INVITATION TO BID  
ADDENDUM NUMBER ONE (1)

RE: BID #2018-82 – EMERGENCY EQUIPMENT FOR TWENTY (20) FORD SUV INTERCEPTORS

OWNER: CITY OF EDINBURG

**Item # 7 Officer/Suspect protective partition:** Setina officer-suspect model #8VS 50%-50% poly-wire mesh coated partitions with full lower expansion kit #8VS Coated Poly Partition (Part# PK0119ITU12) or Department approved equal meeting the following specifications:

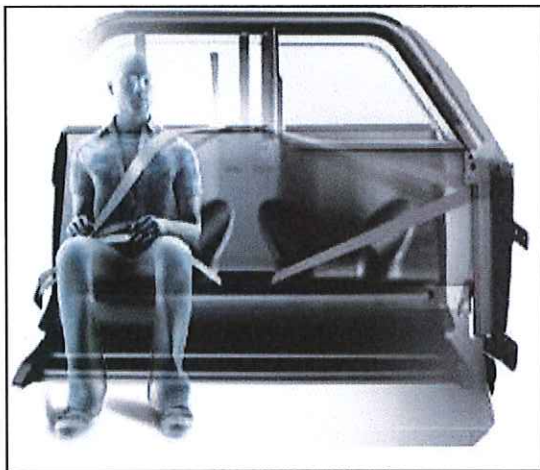
- a) Only wire mesh 1" X 2" poly coated mesh will be acceptable.
- b) The partition shall not allow for gaps exceeding 1" from the top, 3" on the side and 4" on the bottom.
- c) Partitions must not interfere with side curtain air bags and seat belt safety systems.
